## HISTORIC AND DESIGN REVIEW COMMISSION

**HDRC CASE NO:** 2019-649  
**ADDRESS:** 926 LAMAR ST  
**LEGAL DESCRIPTION:** NCB 1655 BLK C LOT 21 495-123753-203  
**ZONING:** R-5, H  
**CITY COUNCIL DIST.:** 2  
**DISTRICT:** Dignowity Hill Historic District  
**APPLICANT:** Bryan Sory/Stillwell Investment Group  
**OWNER:** Stillwell Investment Group  
**TYPE OF WORK:** Addition  
**APPLICATION RECEIVED:** October 27, 2019  
**60-DAY REVIEW:** December 26, 2019  
**CASE MANAGER:** Huy Pham  
**REQUEST:**

The applicant is requesting a Certificate of Appropriateness for approval to:

926 LAMAR STREET  
EAST ELEVATION

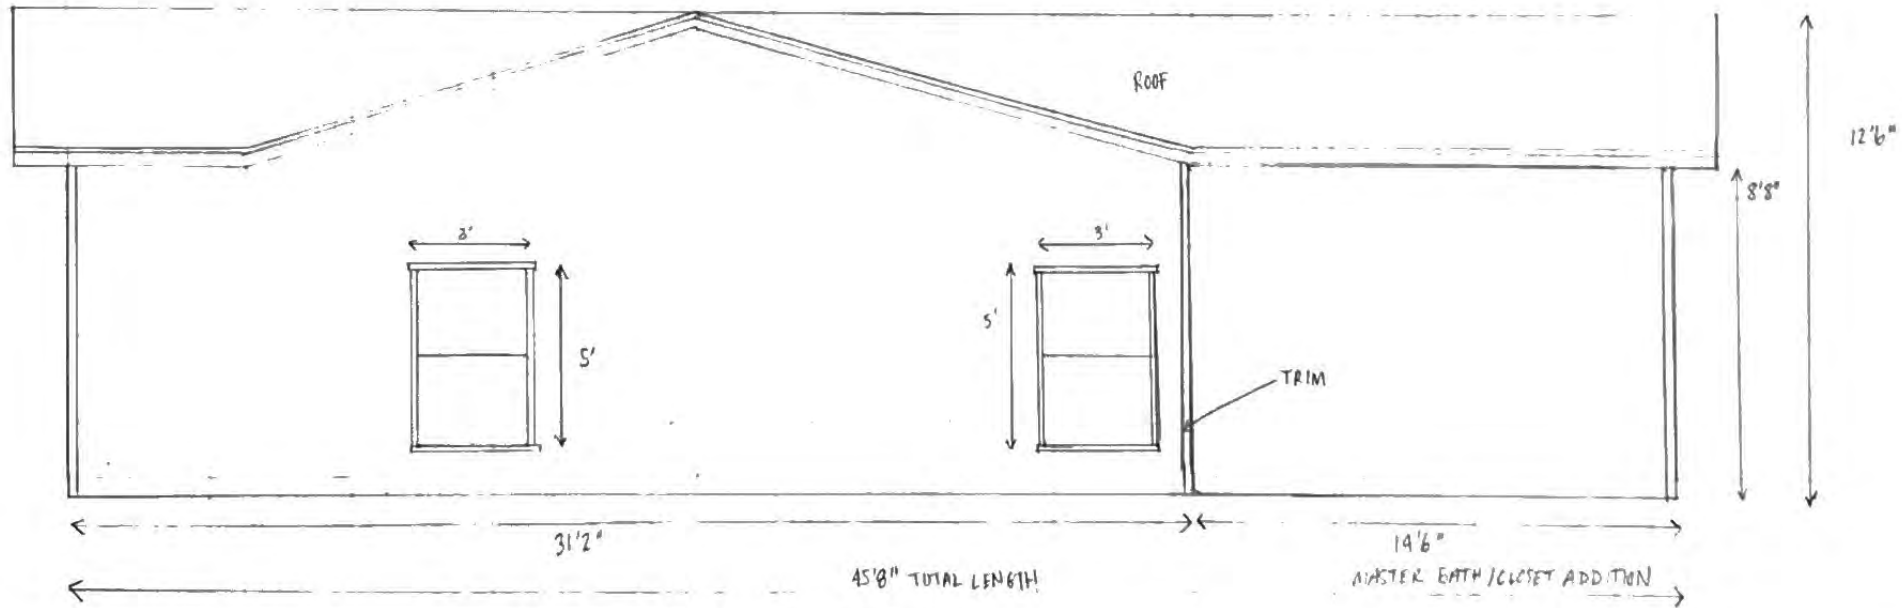
- b. EAST SIDE ADDITION – The applicant has proposed to construct a 230 square foot rear addition, flush to the east elevation. The proposed addition features matching wood siding, a rear facing gabled roof meeting the existing turned gable with composition shingles, a horizontal vinyl window for the interior bathroom, and a vertical trim piece to distinguish between new and old forms. Staff finds that the proposed addition is generally consistent the Guidelines for Additions. However, staff finds that a window size and configuration that relates to the primary historic structure would be more appropriate than the proposed horizontal window.

- 1. Construction of the east elevation rear addition with the stipulation (a) that a window size and configuration that relates to the primary historic structure is used instead of the proposed horizontal window

926 LAMAR STREET  
WEST ELEVATION

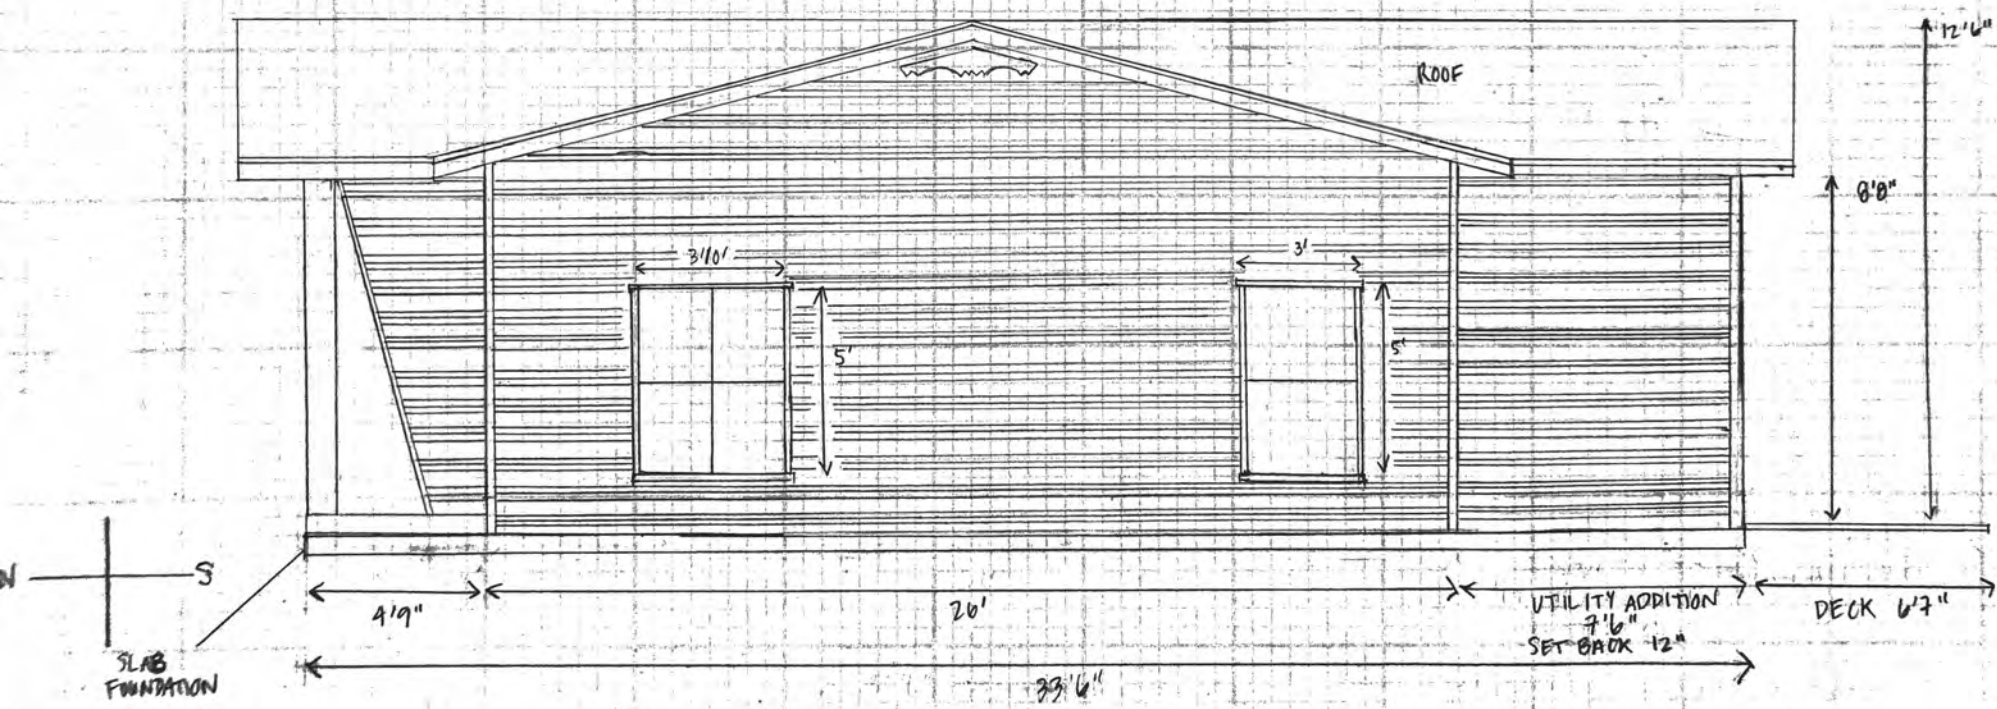
- c. WEST SIDE ADDITION - The applicant has proposed to construct a 68 square foot addition, inset to the west elevation. The proposed addition features matching wood siding, a rear facing gabled roof meeting the existing turned gable with composition shingles, a rear-facing door, and 12 inch inset side wall plane to distinguish between new and old forms. Staff finds that the proposed addition is generally consistent the Guidelines for Additions.

- 2. Construction of the west elevation rear addition
- 3. Removal of the attached planter, with the stipulation (b) that the divider wall is maintained
